Service Bulletin No. 347

MODEL	J4500 Series Coaches	TYPE	Field Change Program	SECTION/GROUP	22 – Wheelchair	DATE	
SUBJECT	BRAUN HYDRAULIC AND ELECTRICAL LINE INTERFERENCE						
CONDITIONS

Ref. NHTSA Recall No.: 11V-XXX

Figure 1.

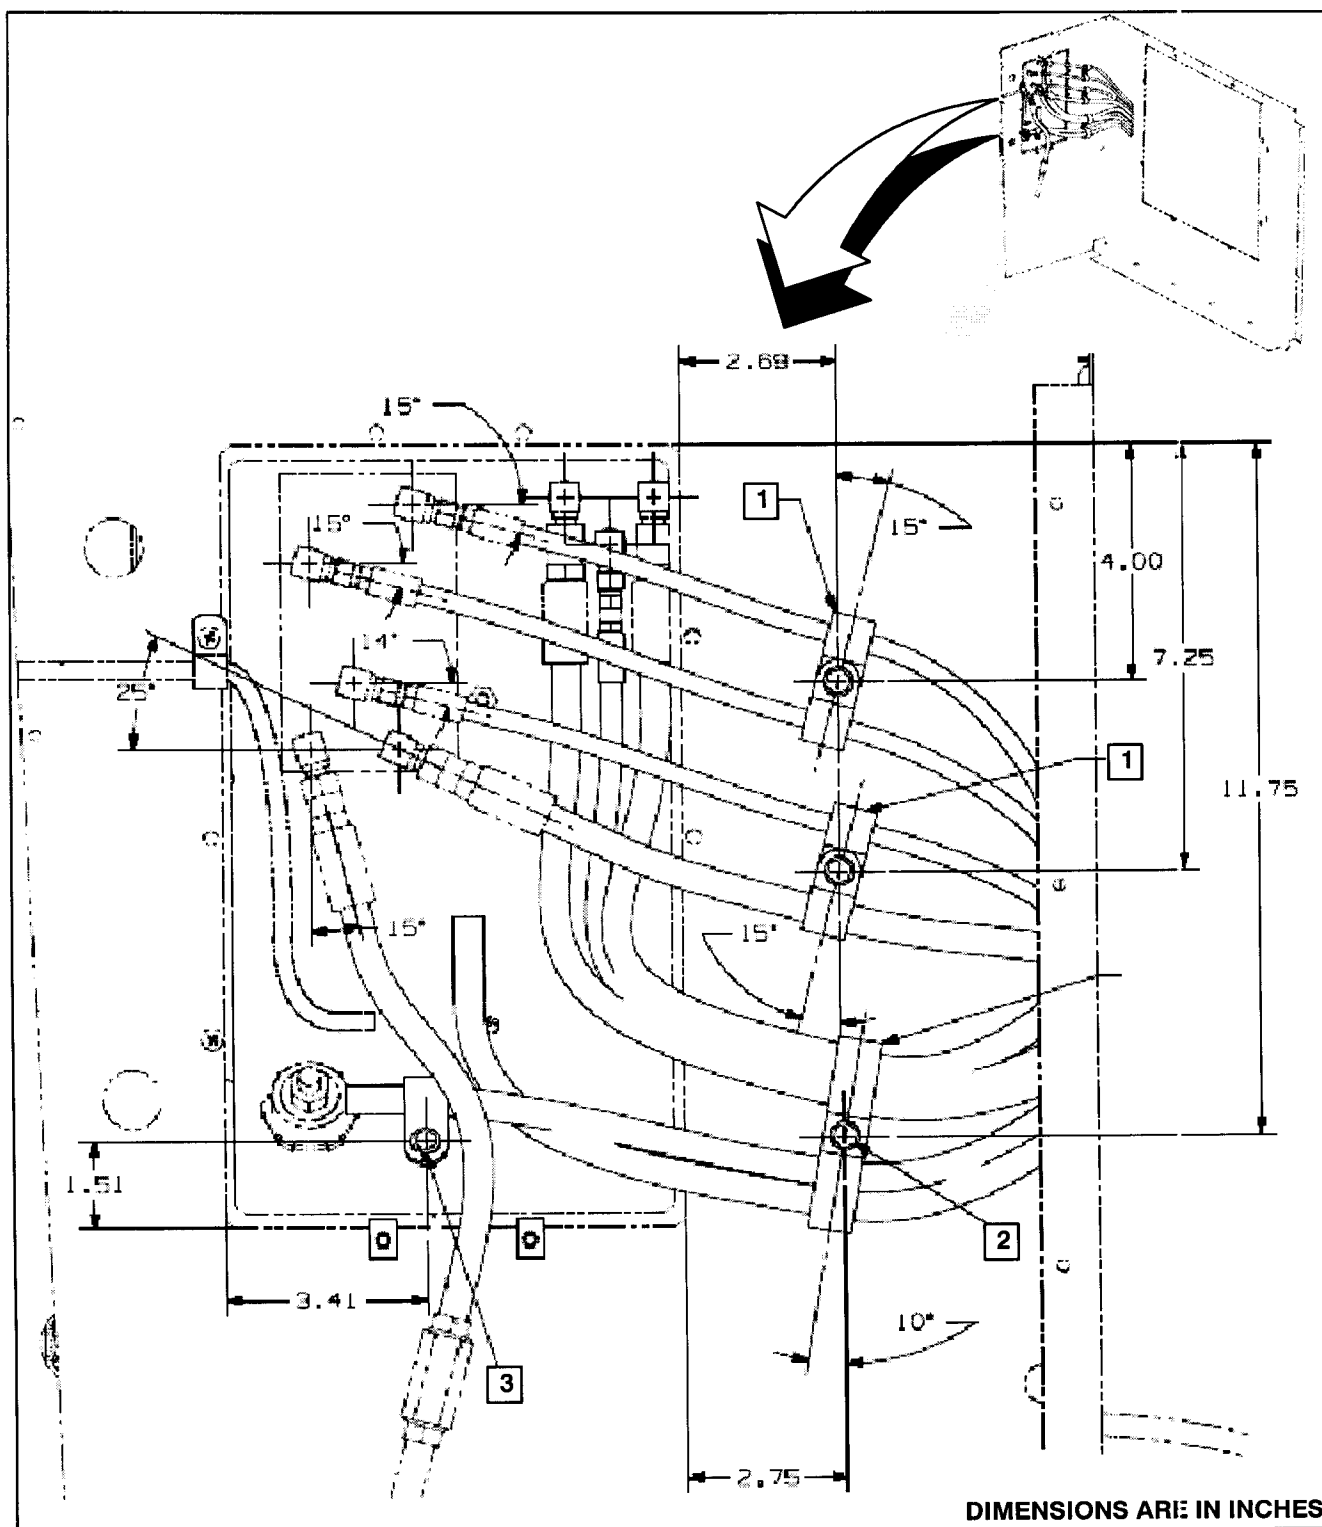
4. Open the curbside, rear side service compartment door.
5. Locate the fittings shown in Figure 1. Orient the harnesses and cables as shown in Figure 1.

6. Using a 13/64 inch drill bit and a drill bit stop (set to the width of the compartment wall), drill three (3) holes at the dimensions shown in Figure 1.

ITEM	FIGURE 1 DESCRIPTION
1	Clamp, p/n 19-4-32, x two (2)
2	Clamp, p/n 19-4-48, x two (2)
3	Re-locate existing clamp (refer to Step 8.)

7. Install the clamps, p/n 19-4-32, and, p/n 19-4-48, on the hoses as shown in Figures 1 and 2. Using screws, p/n 19-4-176, and nut, p/n 19-3-2, secure the clamps to the compartment wall.

Figure 4. Reference photo of mounting hardware on rear, side service compartment side wall.

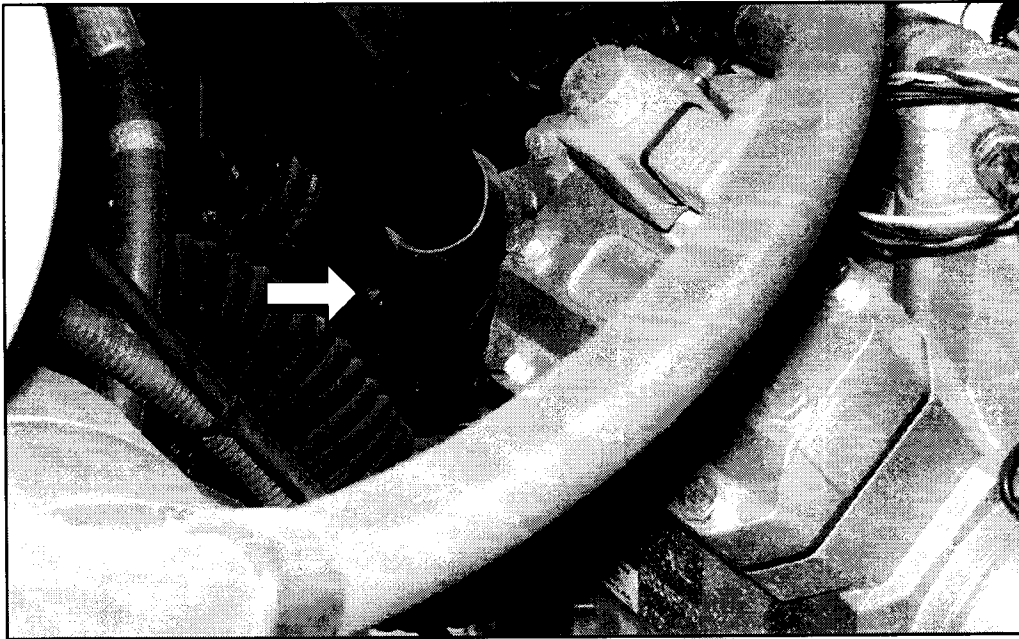
Utilize the rear, side service compartment to access the screw threads (refer to Figure 4).

Figure 5. Reference photo of wheelchair compartment.

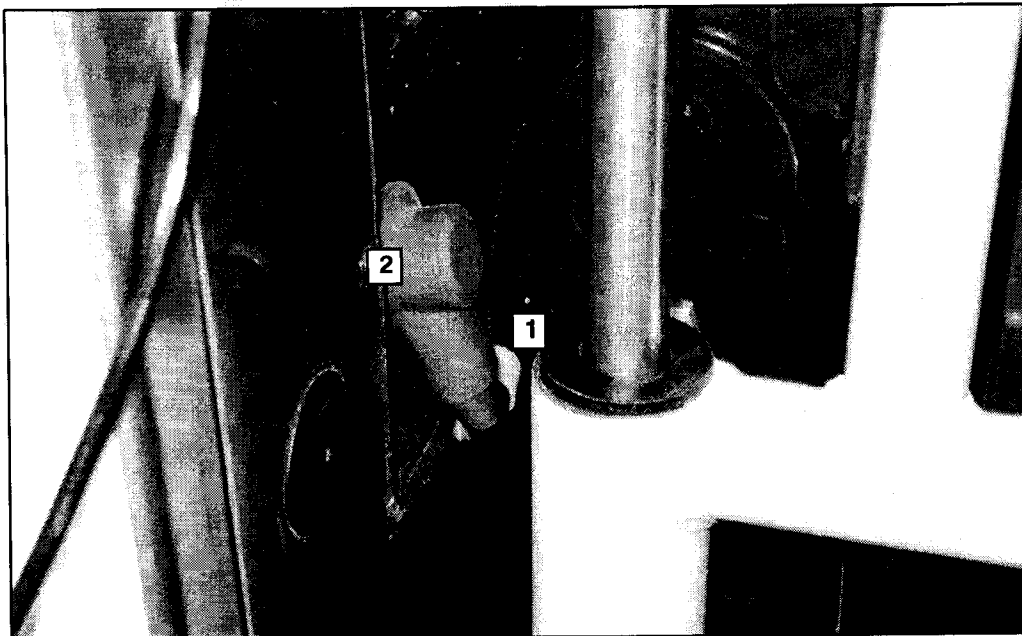
8. Using a 11/64 inch drill bit and a drill bit stop (set to the width of the compartment wall), drill a hole at the dimensions (1.51 x 3.41) shown in Figures 1 and 5. Secure the existing clamp to the compartment wall using screw, p/n 19-1-619, and washer, p/n 19-2-7.

9. In the wheelchair compartment, remove the red protective boot from the one (1) wheelchair lift electrical terminal and apply high tack sealant to the terminal (refer to Figure 5).
10. In the rear, side service compartment, remove the red protective boot from the three (3) wheelchair lift electrical terminals and apply high tack sealant to the terminals (refer to Figure 6).
11. Install the edge molding, p/n 24-51-0050, on the upper bracket edge (below the loom routing) as shown in Figure 6.

Figure 6. Reference photo of rear, side service compartment

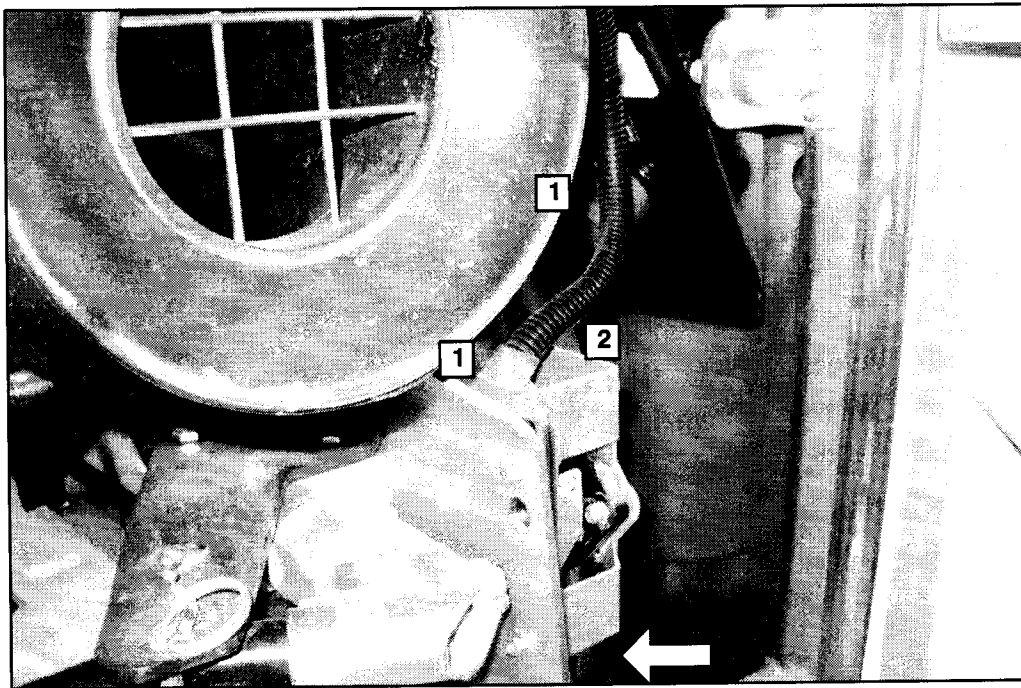
ITEM	FIGURE 6 DESCRIPTION
1	Remove the red protective boot and apply high tack sealant to the terminals
2	Install the edge molding
